March 15, 1991
LD-91-013

Project No. 675

Subject: Response to NRC Requests for Additional
Information

Reference: NRC Letter, Request for Additional Information,
T. J. Kenyon (NRC) to A. E. Scherer (C-E), dated
June 26, 1989

CONTAINMENT TEMPERATURE VS. TIME

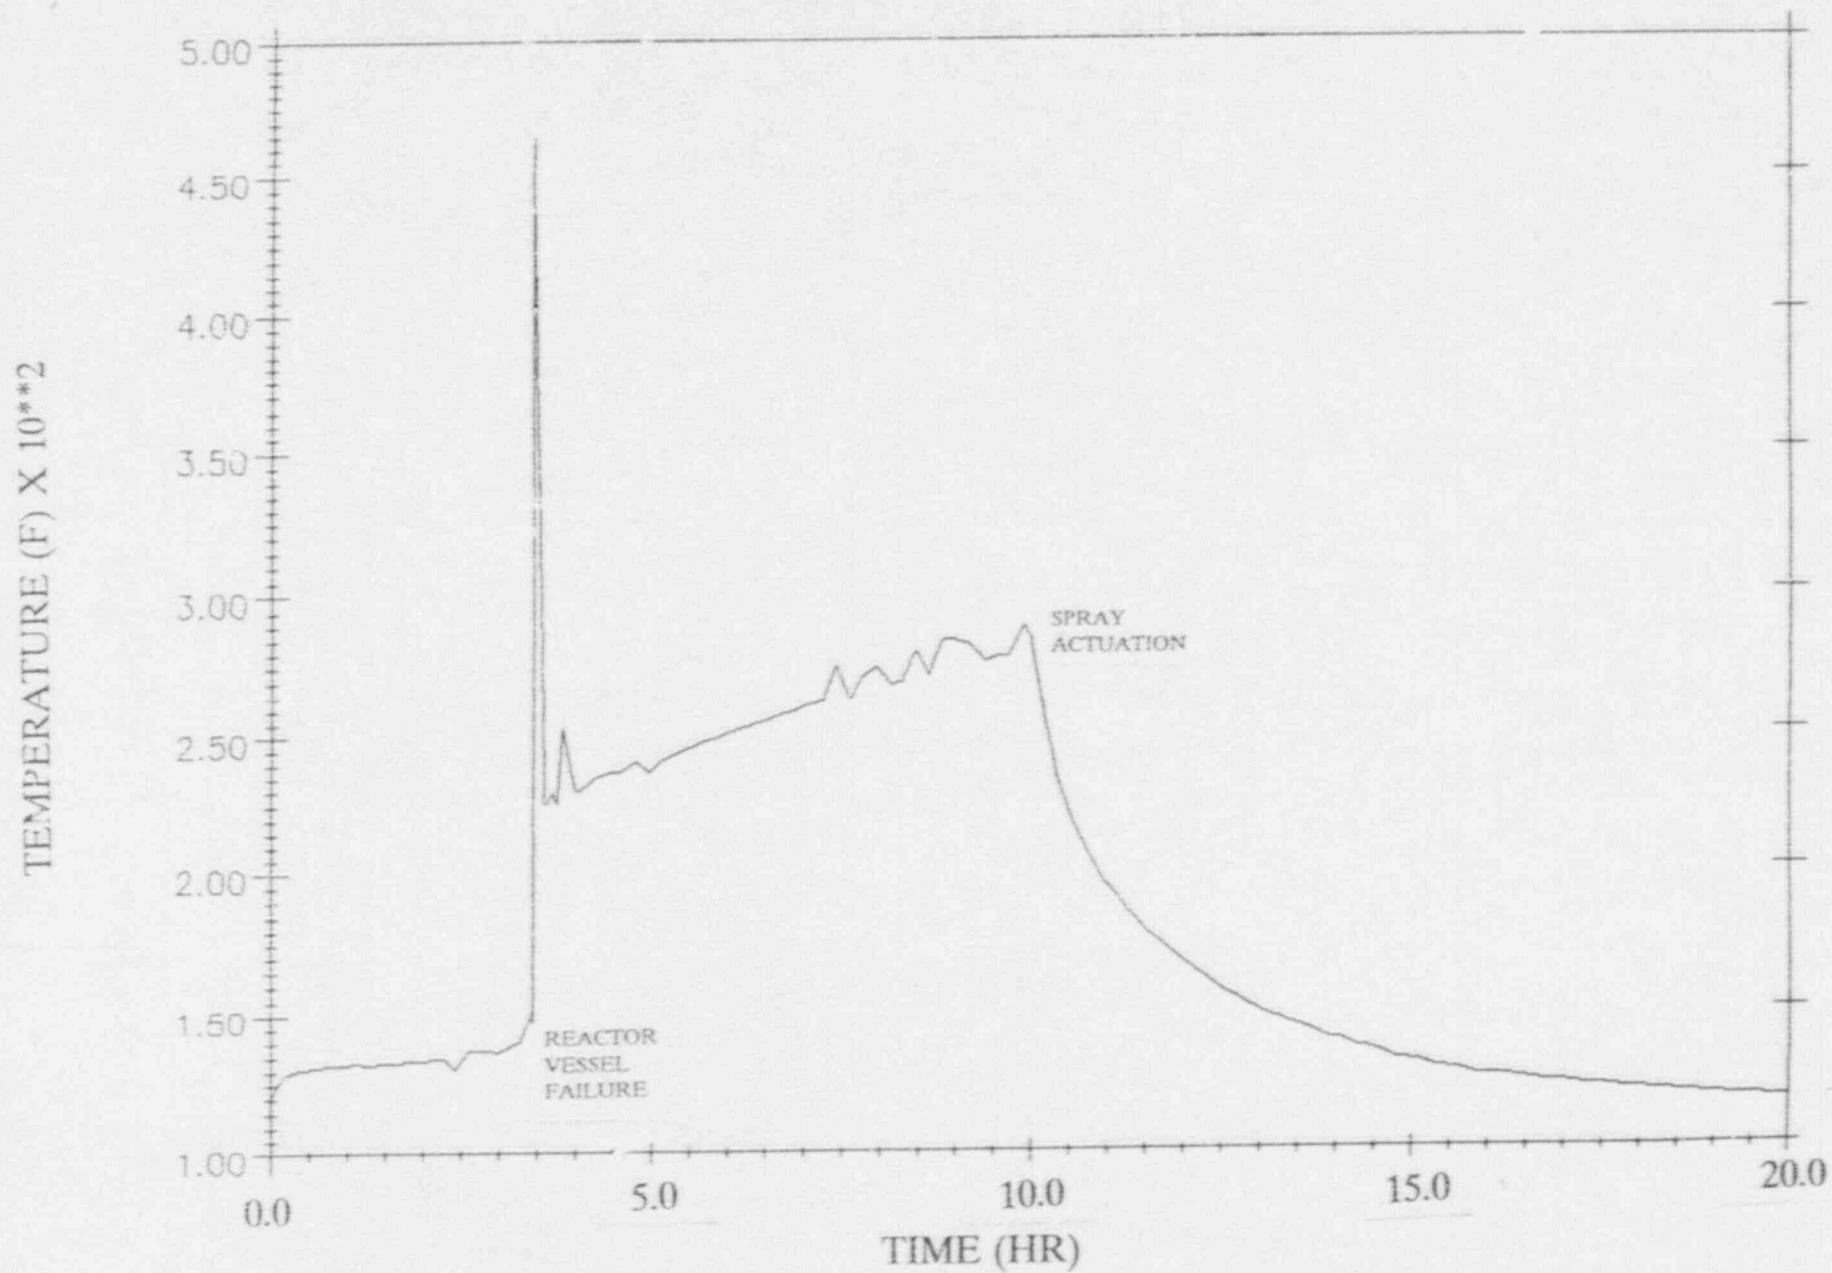
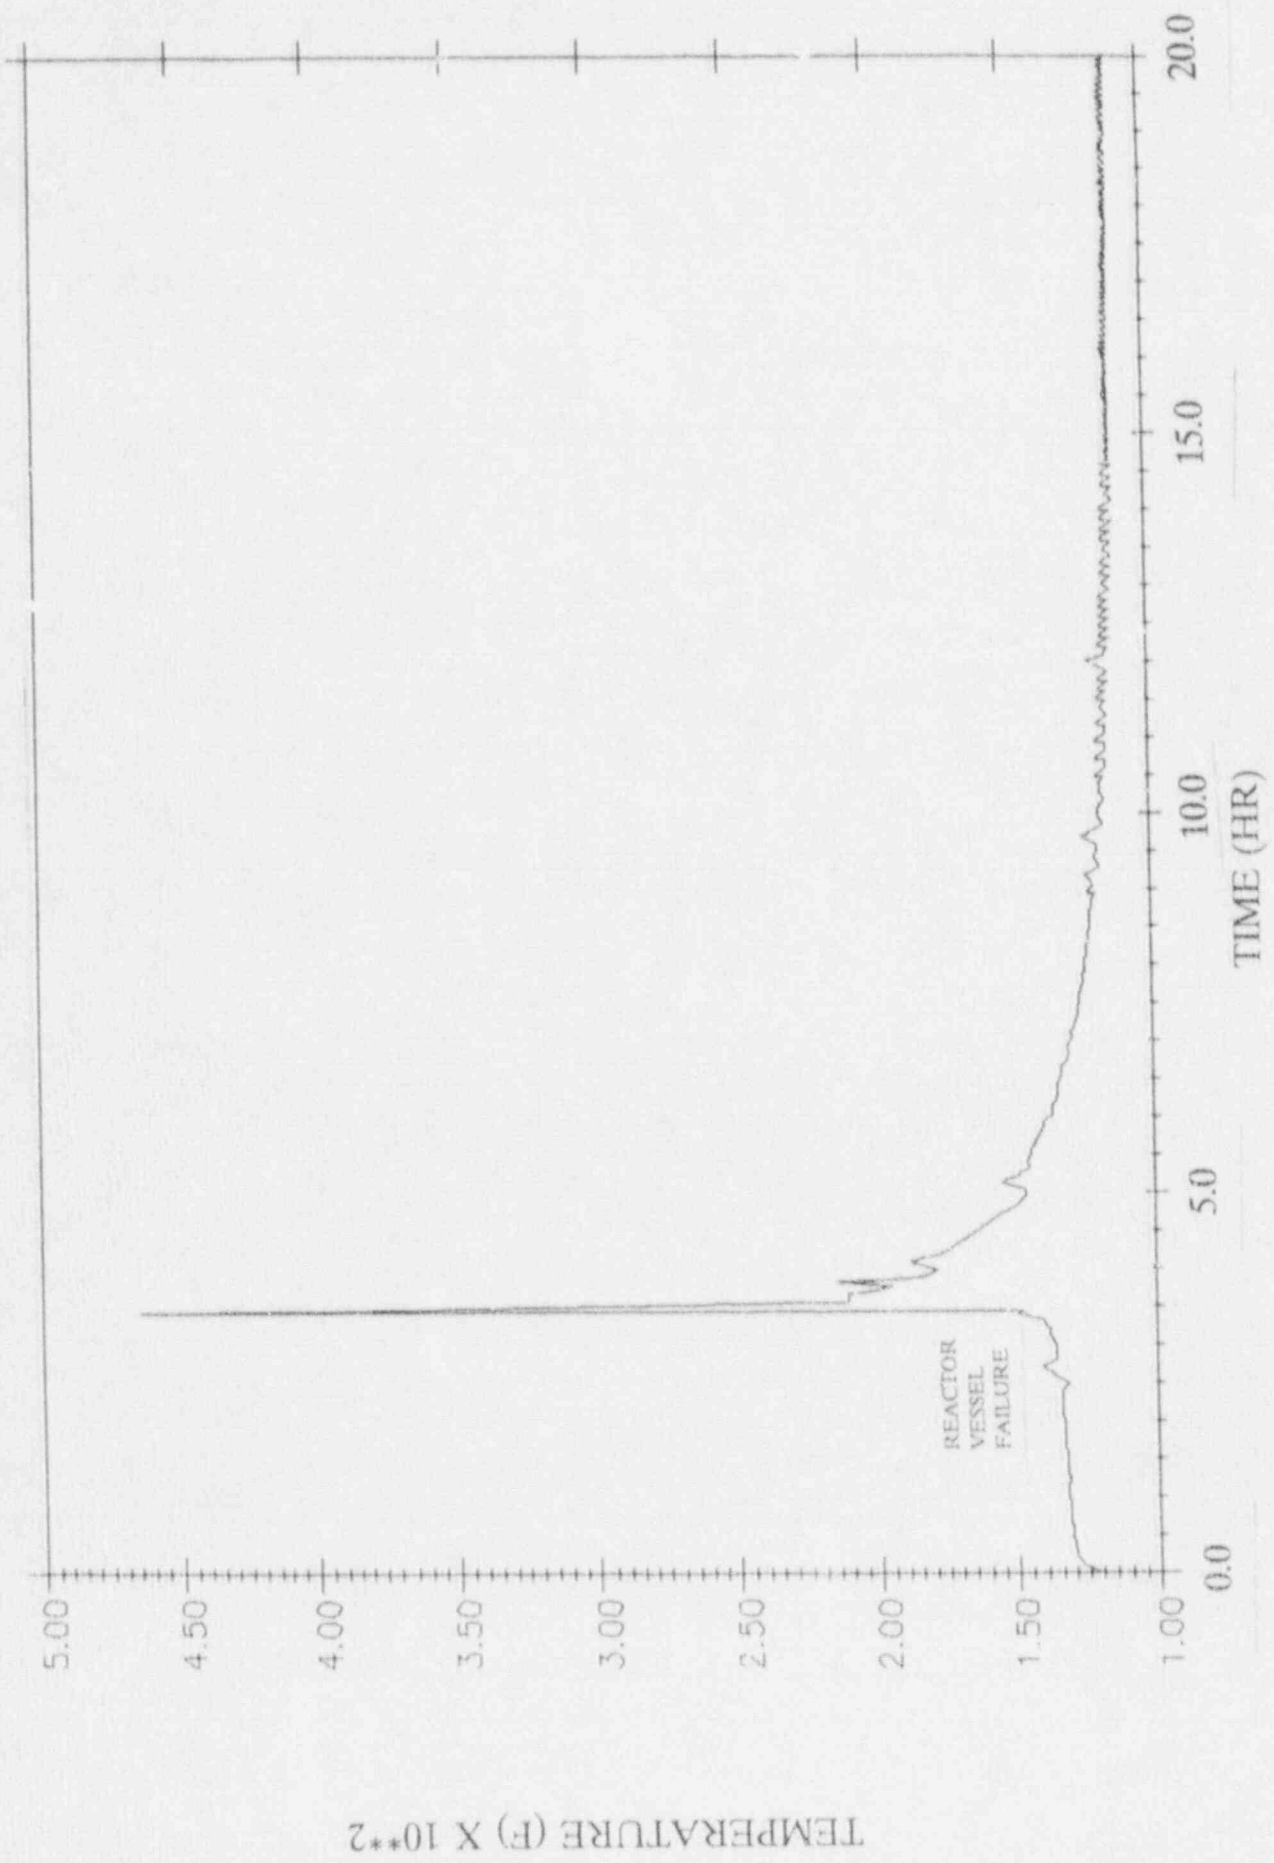
Provide a technical analysis and evaluation of the containment spray system's effectiveness in reducing containment pressure and temperature and lowering radioisotope releases during postulated dominant severe accident sequences. Discuss specific system design features for enhancing the mitigation of severe accident consequences.

An evaluation of the containment spray system is provided in Section 6.5.3 of Amendment I to CESSAR-DC. This section references Section 15.6.5 and Appendix 15A for a discussion of the effectiveness of removing elemental iodine from the containment atmosphere. The MAAP computer code is used for analysis of severe accident scenarios. The attached figures show the effect of the containment spray system in reducing the containment temperature and pressure for a severe accident. The severe accident analyzed is Station Blackout (SBO) and cases of normal spray initiation, delayed initiation, and no sprays are presented.

Design features which enhance the mitigation of severe accident consequences are described in Section 6.5. The safety-grade classification of the Containment Spray System (CSS) provides reasonable assurance that its mitigative function will be accomplished in severe accident environments similar to those predicted by MAAP. Comparison of the containment pressure and temperature for design basis events in Section 6.2.1 of CESSAR-DC to those for the attached case with "early" (normal) spray initiation indicates similar results for design basis and severe accidents. Please note, however, that the design of the CSS results from the design bases listed in Section 6.5, not from specific MAAP analyses.
